## Determination 2018/006

# Regarding the code-compliance of sliding doors that form part of a barrier to a pool at 148 Glenbrook Road, Pukekohe

**Figure 1: Site plan (not to scale)**

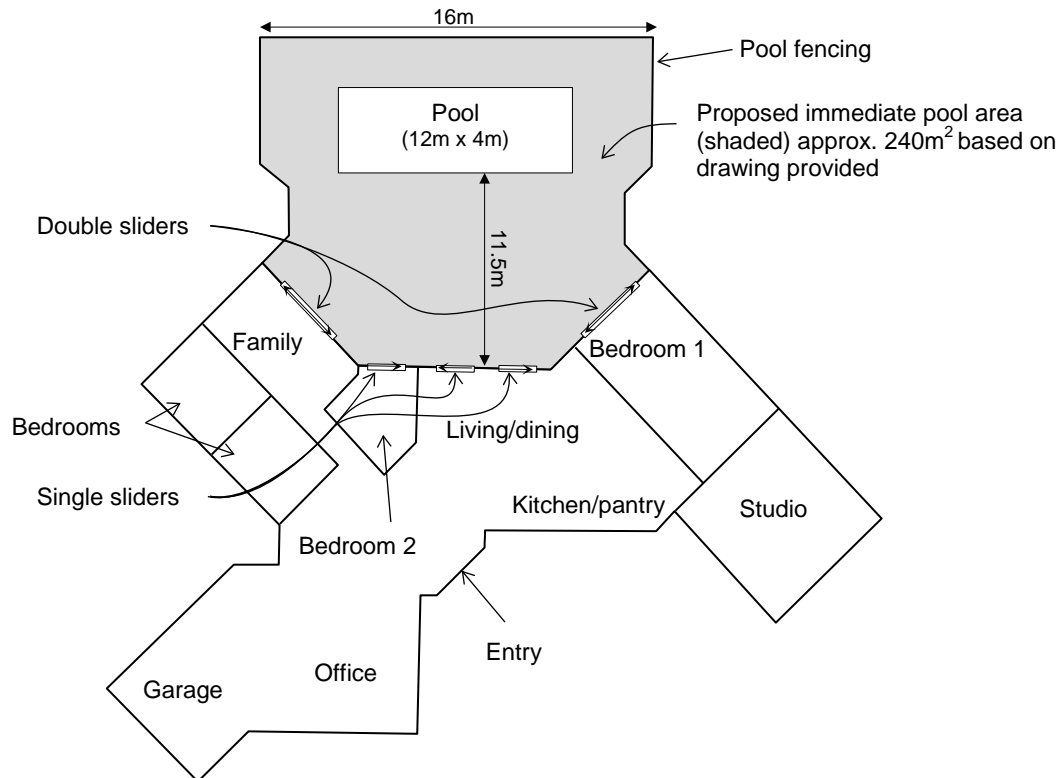
- 2.1 The building work that is the subject of this determination is the proposed use of an exterior wall of the single-storey house to form part of the barrier to the swimming pool. The wall contains five sliding doors which open into the immediate pool area, as shown below.

- 2.2 The doors are not self-closing or self-latching. The width of the sliding doors and maximum width of the opening leaves, as advised by the applicant, are as follows:

<b>Door size</b>	<b>Maximum opening</b>
<u>Single leaf doors</u>		
Living:	1343 mm	1170 mm
Dining:	964 mm	870 mm
Bedroom 2:	1031 mm	810 mm
<u>Double leaf doors</u>		
Family:	1029 mm (each leaf)	1760 mm
Bedroom 1:	771 mm & 770 mm	1260 mm

1. You are proposing to have five doors opening into the pool area, 2 of which are opening off bedrooms. Sleeping is not an activity related to swimming, bathing and wading and doors are not permitted off bedrooms.
2. Also 2 of the doors are double sliders which are not allowed, as the doors must only open no more than 1m as per [Acceptable Solution F9/AS1] 4.2.1. You would have to permanently fix shut one of the doors and have the other opening no more than 1m. ...
3. ...
4. NZS8500-2006. This is not a compliance document and is no longer relevant under the Building Code F9. [Acceptable Solutions F9/AS1 and F9/AS2] are the only acceptable solutions at this stage, as we are not accepting any alternative solutions.

- the five doors all open more than 1m
- the authority had requested confirmation that the doors would be restricted to opening no more than 1m, but the applicant did not confirm that prior to making the application for determination
- if the opening width issue is resolved, the authority's main concern is the number of doors creating a pedestrian access way through the immediate pool area from bedrooms to the living room/kitchen.

- 5.3.9 The area enclosed by the proposed barrier encompasses the whole of the outdoor living area, is approximately 240m<sup>2</sup>, is adjacent to the living areas and has a number of doors that provide for indoor/outdoor flow. From the site plans provided it appears there are no other alternative outdoor living spaces, such as another courtyard or patio. I am of the view there is a high likelihood of the outdoor area functioning as an extension to the living area of the house.

- 5.3.10 Taking into account: the number, size and location of the doors; the location and size of the immediate pool area proposed; and the relationship of the proposed immediate pool area with the living and bedroom areas of the house – I do not accept the area encompassed by the external wall of the house in this case can properly be considered the “immediate pool area”.

- 5.3.11 Having come to the view that the proposed barrier does not enclose the immediate pool area, I conclude that the proposed barrier does not comply with Clause F9.3.2(a) of the Building Code.

- 6.1 In accordance with section 188 of the Building Act 2004, I hereby determine that the proposed barrier that incorporates the external wall of the house does not comply with Clause F9 of the Building Code.
